YS-010-10

SUBJECT: Fan Grill Rattling on Predator 6.5 through 12.5 ton Units.

UNITS: DF078-120, DH078-150, ZH078-150, DM078-150, DR090-150, ZR078-150, BA-078-150
XP078-150

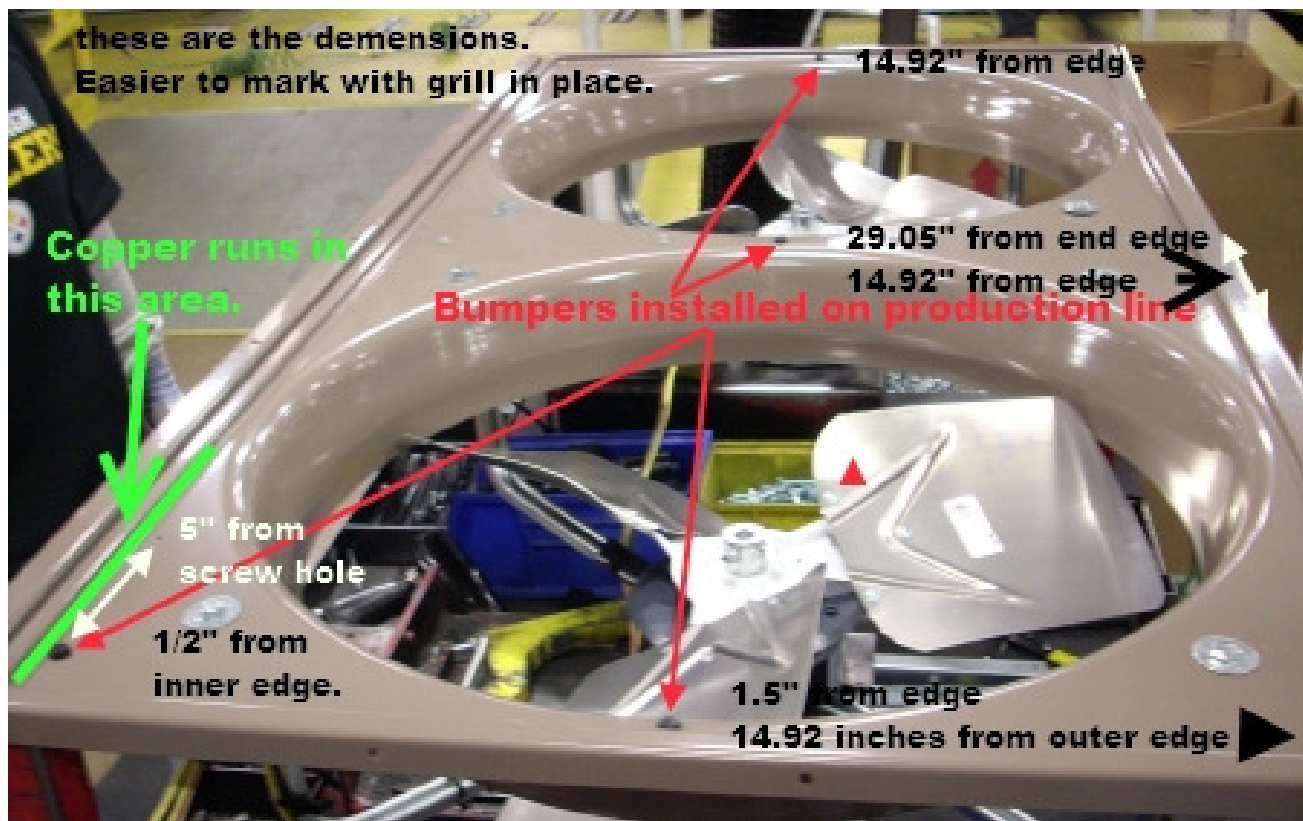
You will have to drill 4 - 3/16" holes in the locations shown. Mark the hole location prior to removing the fan grill. The large diameter cross bar will rest on top of the bumper.

The three locations marked with a red circle are not a problem. The area beneath the deck is clear.

The location marked with the **blue** circle in the lower right of the above picture is critical and should be approached carefully. **Refrigerant piping is located in that area.** You will need a 3/16" metal drill bit with a depth limiter when drilling the hole in the corner location. If you do not have a special bit with a depth limiter, then you can cut a piece of copper that fits over the bit, allowing only about 1/8" of the bit to be exposed. Or, you could use duct tape to wrap the bit four or five times to expose only the 1/8" of bit. **DO NOT TRY TO DRILL THE HOLE WITHOUT SOME TYPE OF DEPTH LIMITER.**

DAMAGE TO COPPER LINES COULD RESULT.

Drill the holes and insert the bumpers. Re-install the fan grill. Turn disconnect back on and verify operation of the unit.
